Access Compliance Report Public Rights-of-Way (Curb Ramps)

Intersection ID: N/A Main Street: CALAWOOD_WY Cross Street: BECKSTONE_WY Location: SE

ADA ID: A4337A58352B Ramp Type: BlendTrans1 Initial Pass/Fail: Fail Overall Compliance: No Severity Score: 8.75

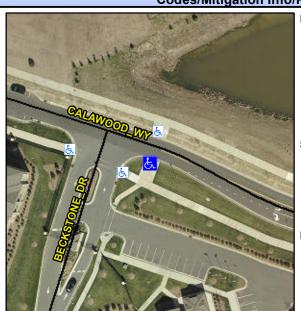
Not Found, R304.5.1

Not Found, R304.5.1

Comp	liance Description	Data	Compl	liance Description	Data
N/A	Ramp Length (in)	57.0	Yes	BlendTrans Slope (%)	4.8
No	Ramp Width (in)	46.0	Yes	BlendTrans XSlope (%)	0.6
N/A	Flare Type LT	N/A	N/A	Flare Type RT	N/A
N/A	Flare Slope LT (%)	N/A	N/A	Flare Slope RT (%)	N/A
N/A	Flare Traversable LT?	N/A	N/A	Flare Traversable RT?	N/A
N/A	Landing Length (in)	N/A	N/A	DWS Provided?	N/A
N/A	Landing Width (in)	N/A	N/A	DWS Contrast?	N/A
N/A	Landing Slope (%)	N/A	N/A	DWS Length (in)	N/A
N/A	Landing X Slope (%)	N/A	N/A	DWS Full Width?	N/A
N/A	Landing Curb? (Y/N)	N/A	N/A	DWS Offset (in)	N/A
N/A	Shared Landing?	N/A			
N/A	Gutter Ponding?	N/A	N/A	Gutter Slope (%)	N/A
N/A	Gutter Lip Ht (in)	N/A	N/A	Gutter X Slope (%)	N/A
N/A	Painted X Walk1?	No	N/A	Painted X Walk2?	N/A
	X Walk 1 Direction	To N		X Walk 2 Direction	N/A
	X Walk 1 Width (in)	N/A		X Walk 2 Width (in)	N/A
	X Walk 1 Slope (%)	1.1		X Walk 2 Slope (%)	N/A
	X Walk 1 X Slope (%)	1.0		X Walk 2 X Slope (%)	N/A

Remove & Replace Curb Ramp With
Two New Directional Ramps or
Equivalent.
